United States Patent and Trademark Office

APPLICATION NO.	FILING DATE	FIRST NAMED INVENTOR	ATTORNEY DOCKET NO.	CONFIRMATION NO.
10/764,788	01/26/2004	Edward L. Gibbs	016 9762	
27193 7590 06/21/2007 GARY PETERSON			EXAMINER	
	SON AVE., SUITE 450		MACARTHUR, VICTOR L	
OKLAHOMA CITY, OK 73102			ART UNIT	PAPER NUMBER
		•	3679	
	•		MAIL DATE	DELIVERY MODE
			06/21/2007	PAPER

DETAILED ACTION

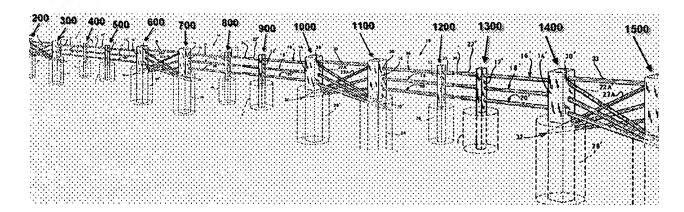
Claims 9-20 are rejected under 35 U.S.C. 103(a) as being unpatentable over Crisp (U.S. Patent 4,979,817) (see marked-up duplicated drawing below).

Claims 9-20. Figure 1 of Crisp shows a fence with a length of about 200 ft (since each cable is about 100 ft, col.3, 1l.30-35). The cutaway ends of the figure 1 assembly imply that the fence continues for a length greater than that expressly shown in figure 1, however the exact length is not expressly stated. Crisp states that the fence surrounds property to secure larger areas such as diplomatic embassies (col.1, ll.10-15; 40-45 and col.2, ll.59-62). One of ordinary skill in the art at the time the invention was made would have easily recognized that surrounding the perimeter of an area such as a diplomatic embassy would require repeatedly duplicating the figure 1 assemblage of Crisp to obtain a fence long enough to surround an embassy. It has generally been recognized that duplicating the components of a prior art device is a design consideration within the skill of the art. In re Harza, 274 F.2d 669, 124 USPQ 378 (CCPA 1960). Therefore, it would have been obvious to one with ordinary skill in the art at the time the invention was made to repeatedly duplicate the figure 1 fence portion of Crisp, for the disclosed benefit of surrounding a large area such as an embassy, since such practice is a design

consideration within the skill of the art. Such modification would necessarily result in the marked-up duplicated version of figure 1 shown above, wherein in addition to the first plurality of posts (300-600) there is a second plurality of posts (700-1000) and third plurality of posts (1100-1400); and in addition to the first rail system (bottom 24) there is a second rail system (middle 24) and third rail system (top 24). This modified version of Crisp suggests all of the limitations of claims 9-20 as best understood by the examiner. See 35 U.S.C. 112 rejection above.
